Conservation Commission Meeting

Regarding: 10-30 Manley Way
Response to Conservation Commission Comments

This letter is in response to the comments made by the Conservation Commission at the meeting on June 5th, 2024.

BMP-1: BMP Location Plan – 1
BMP-2: BMP Location Plan – 2
Snow Storage Plan

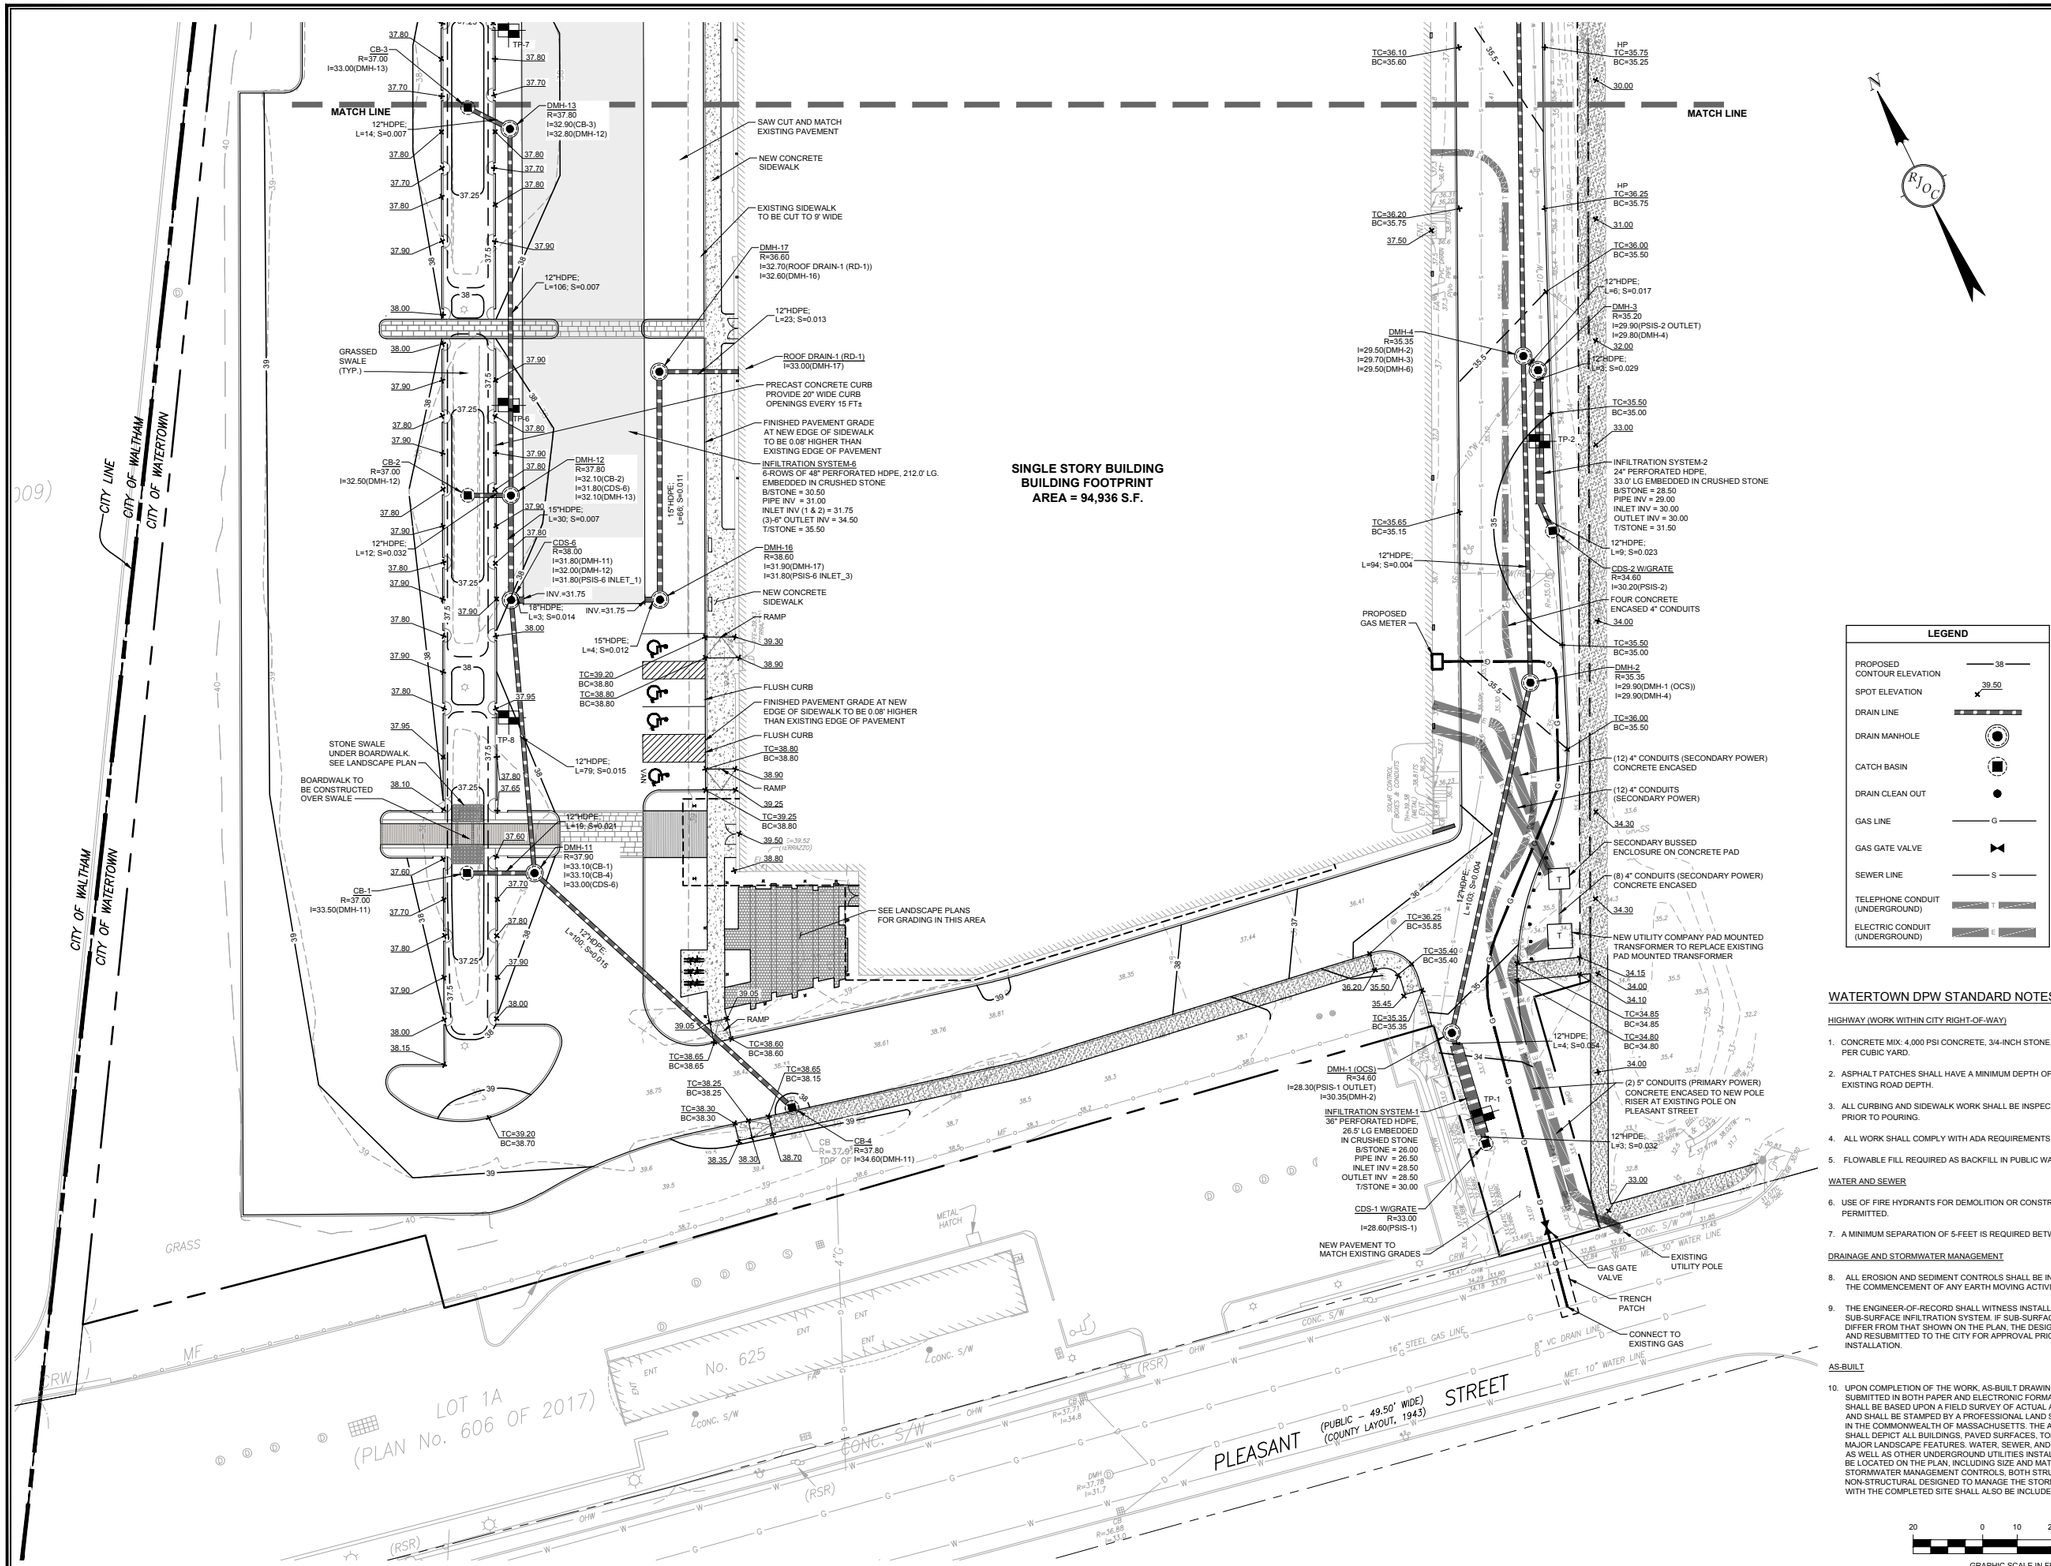
6. *Include snow storage in the O&M plan. Specify low deicing/more environmentally friendly deicing measures including spread rate.*

- **A Snow Storage Plan has been provided in Appendix B of the Operation and Maintenance Plan (O&M). Additionally, Section 4, Snow Management, of the O&M has been revised to specify the use of calcium chloride for onsite deicing at the minimal rate necessary to provide for safe vehicular and pedestrian travel. The O&M notes that the property manager will monitor the application rate of calcium chloride to make sure it is kept to a minimum while ensuring safe conditions for pedestrians and vehicles.**
